Request for Additional Information No. 371, Supplement 13

U. S. EPR Standard Design Certification

Docket No. 52-020

Question 03.07.02-69:

Figure 03.07.02-69-1—Vertical Pressures on NI and Shear Key Basemats

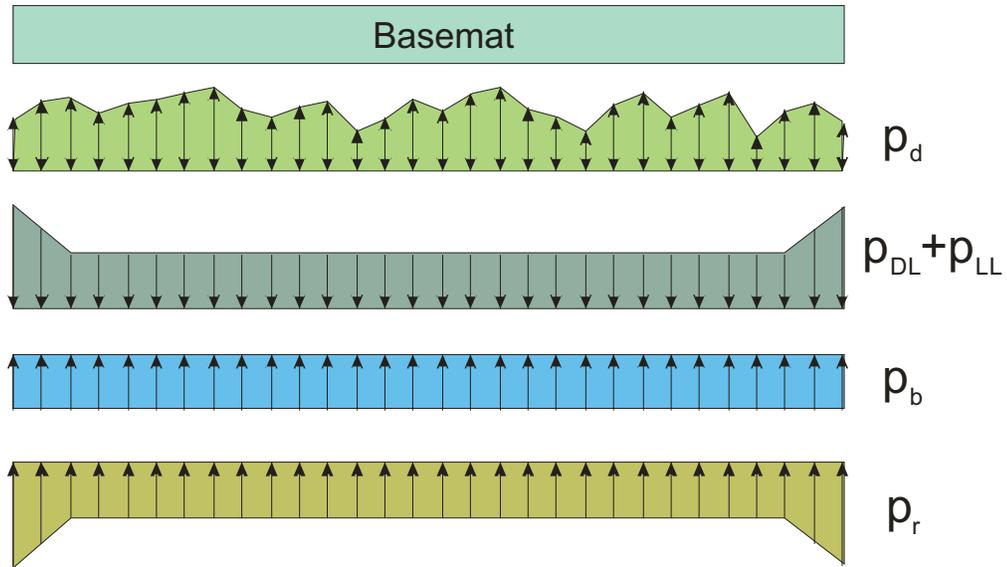
The static and dynamic pressures acting on the basemat and sidewalls of the NI foundation is shown in Figures 03.07.02-69-1 and 03.07.02-69-2, respectively. Figure 03.07.02-69-3 shows the pressures acting on the shear key. The static pressures include the weight of the structure (dead and live load) including buoyancy, hydrostatic forces, lateral soil pressures (active, passive, and at-rest), and surcharge loads. The dynamic soil pressures are a result of the seismic input motion applied in the horizontal and vertical directions. With the exception of the dead plus live loads and dynamic loads calculated directly in terms of nodal forces, the other loads are calculated as pressures and converted to nodal forces on the basemats and sidewalls of both the NI and shear key using the respective tributary area of each node.

Figure 03.07.02-69-5—Vertical Nodal Forces at Bottom of NI and Shear Key Basemats

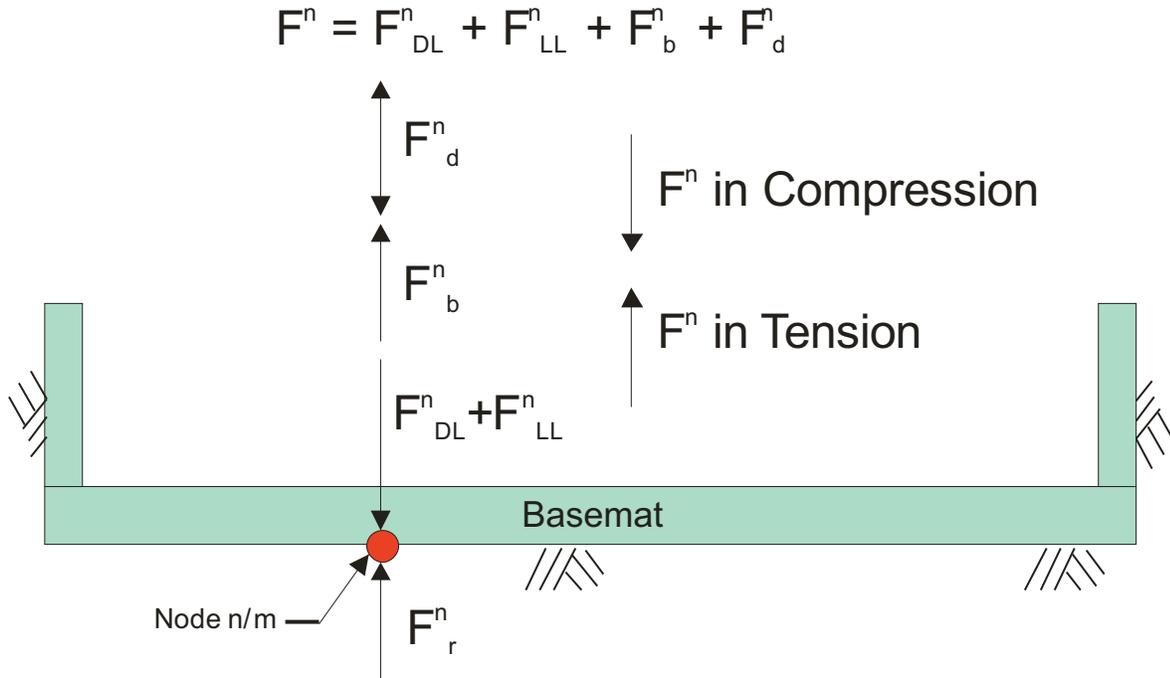
Figure 03.07.02-69-5 shows the static and dynamic nodal forces acting on the NI and shear key basemats. Figure 03.07.02-69-6 and Figure 03.07.02-69-7 show the static and dynamic nodal forces acting on the NI and shear key sidewalls for the active and passive soil states, respectively.

At each time step, the total global horizontal driving (F_x^D) and resisting (F_x^R) forces are calculated following the procedure described in this section. The calculation of the forces is at node level, as shown in Figure 03.07.02-69-5, Figure 03.07.02-69-6, and Figure 03.07.02-69-7. This allows monitoring of any tensile soil stresses on the NI and shear key basemats that may result in debonding. For the nodes that exhibit tensile soil stress (i.e., debonding), zero frictional resistance is assigned. However, the vertical forces are included in the calculation of the net vertical bearing force.

Figure 03.07.02-69-6—Horizontal Nodal Forces on NI and Shear Key Sidewalls in Active State

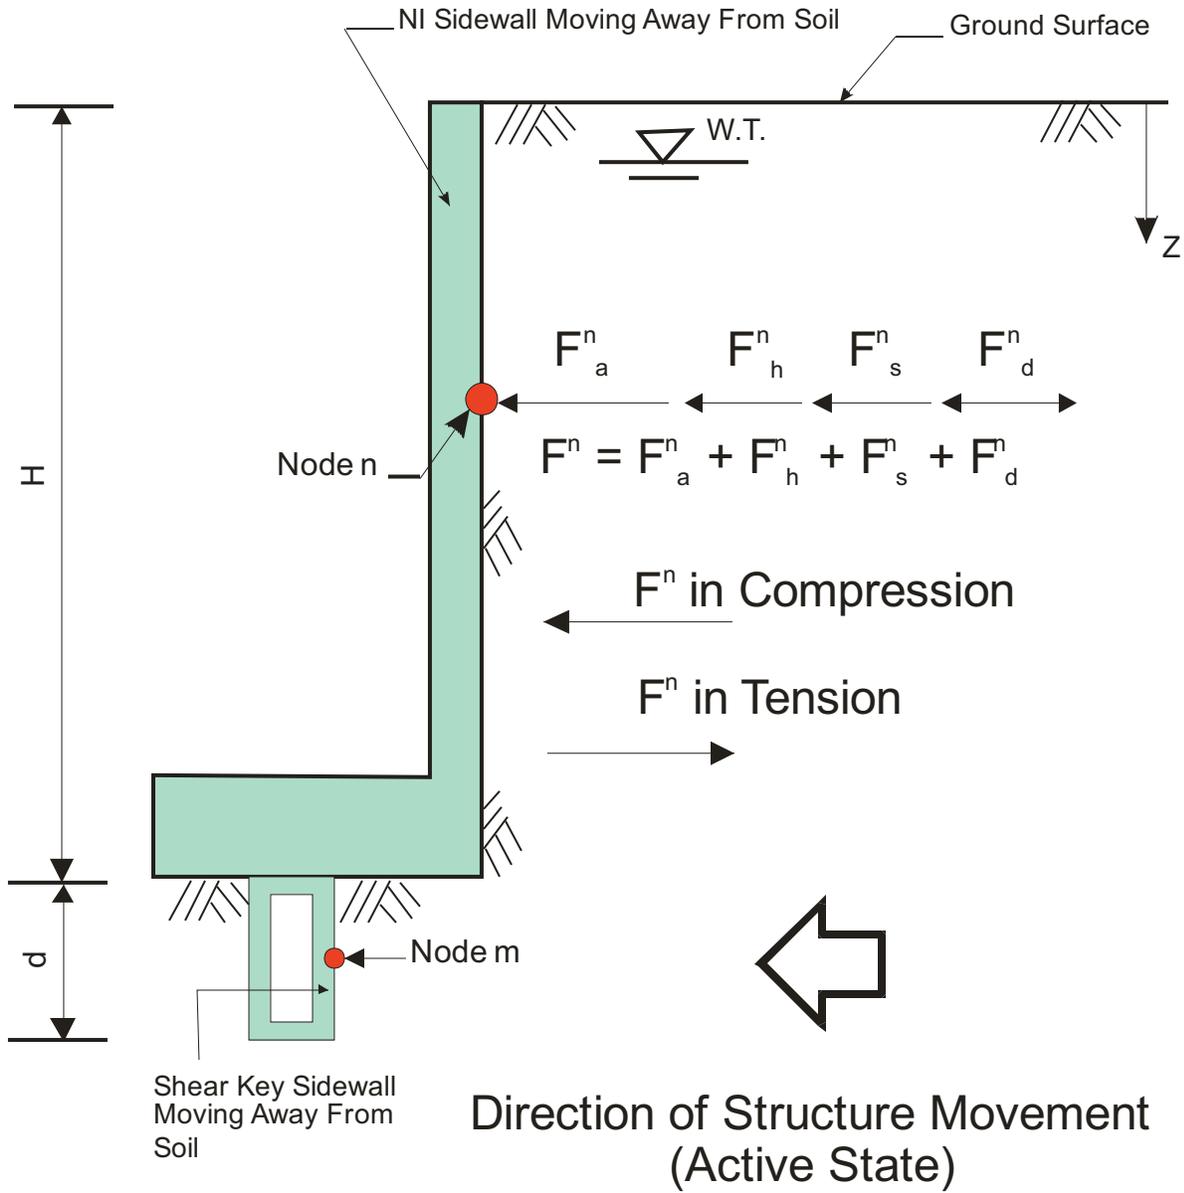
At each time step, the total horizontal driving forces in the x- and y-directions at each interaction node are calculated by summing the following co-directional forces, as applicable (see Figure 03.07.02-69-6 and Figure 03.07.02-69-7):

Figure 03.07.02-69-8—Vertical Foundation Bearing Pressures

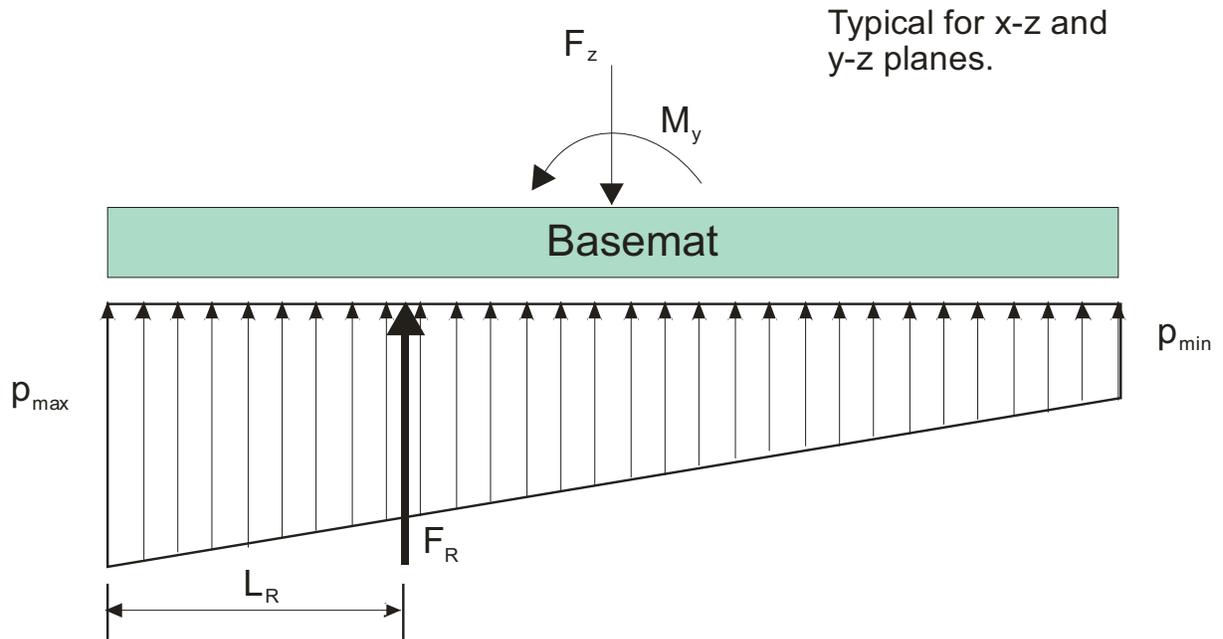
The applied loads on the X-Z or Y-Z plane are shown in Figure 03.07.02-69-8. F_z , M_x , and M_y represent the total vertical force and overturning moment about x- and y-axis, respectively, because of static and dynamic loads acting on the basemat and sidewalls. If $p_{min} < 0$ as shown in Figure 03.07.02-69-9, the foundation compressive bearing pressures are distributed over a reduced net bearing area. The p_{max} and L_R may be calculated by satisfying the equilibrium of vertical forces and moments acting on the foundation through an iterative procedure. If the foundation area subjected to uplift is small, the increase in maximum edge pressure due to uplift is conservatively calculated as $p_{max_adjusted} = p_{max} + |p_{min}|$.

Figure 03.07.02-69-11—Drucker-Prager Model Yield Surface

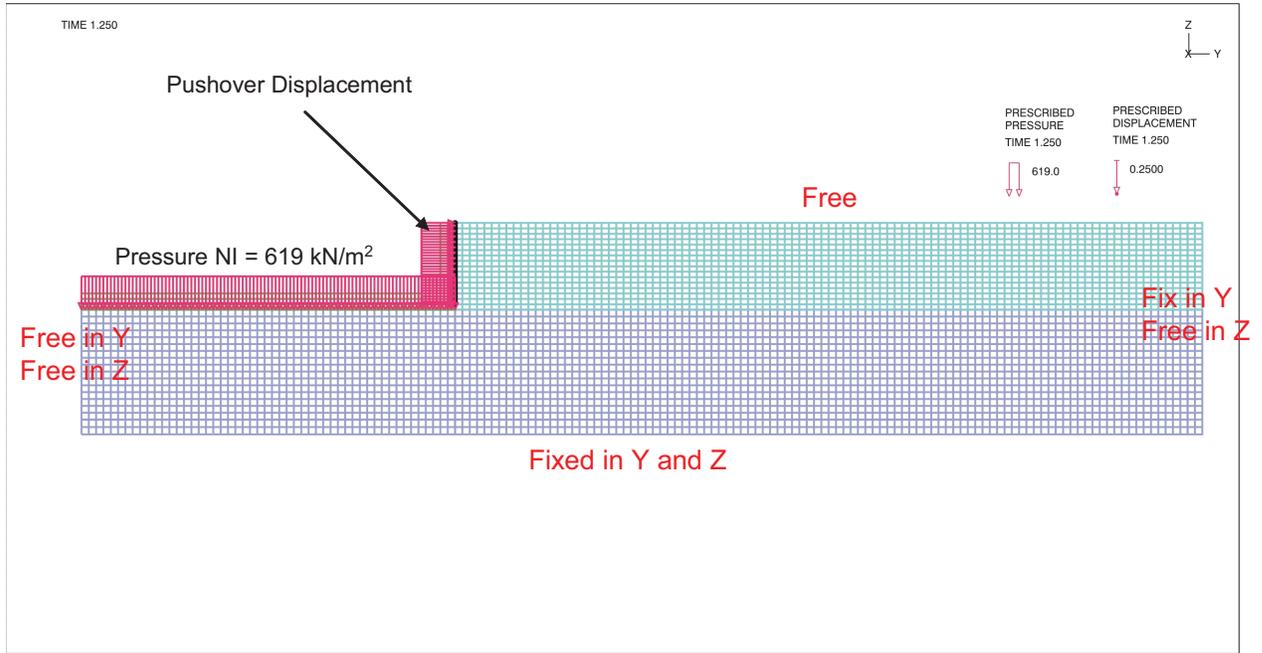
The soil stress-strain behavior is modeled using the Drucker-Prager constitutive model. The yield surface is characterized by a cone, as shown in Figure 03.07.02-69-11. The soil behavior is elastic until it reaches the yield surface. Once yielded, the soil stress-strain is tangent to the yield surface. The yield surface for Drucker-Prager model is compared with that of the Mohr-Coulomb model in Figure 03.07.02-69-12. Because the tension resistance is specified as zero and the cap is set at very high stresses, the model is in close agreement with the Mohr-Coulomb model.

Figure 03.07.02-69-15— K_p vs. Wall Displacement, Smooth Wall, Soil Case 1n5ae

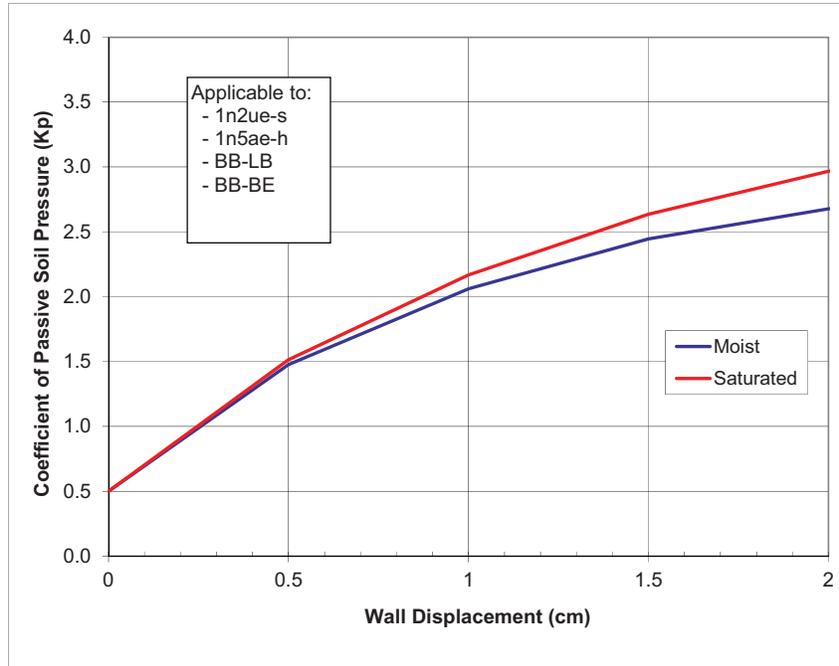
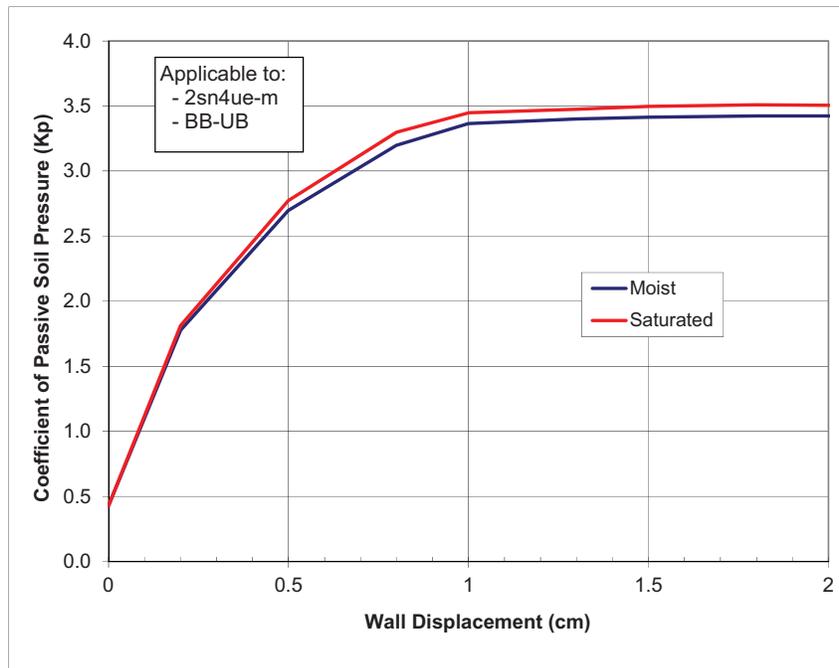
Once the at-rest soil condition under static loads is established, the wall is pushed into the side soil/backfill in the horizontal direction by incrementally increasing displacements using a displacement-controlled procedure. The push is continued until the soil/backfill behind the wall fails within the passive wedge, resulting in large wall displacements without any significant increase in soil resistance. The push analysis results in terms of the wall displacements versus the lateral force exerted on the wall are calculated and shown in Figure 03.07.02-69-13 and Figure 03.07.02-69-14. The relationship between K_p and wall displacement is calculated as shown in Figure 03.07.02-69-15 and Figure 03.07.02-69-16, where passive soil pressures can be estimated.
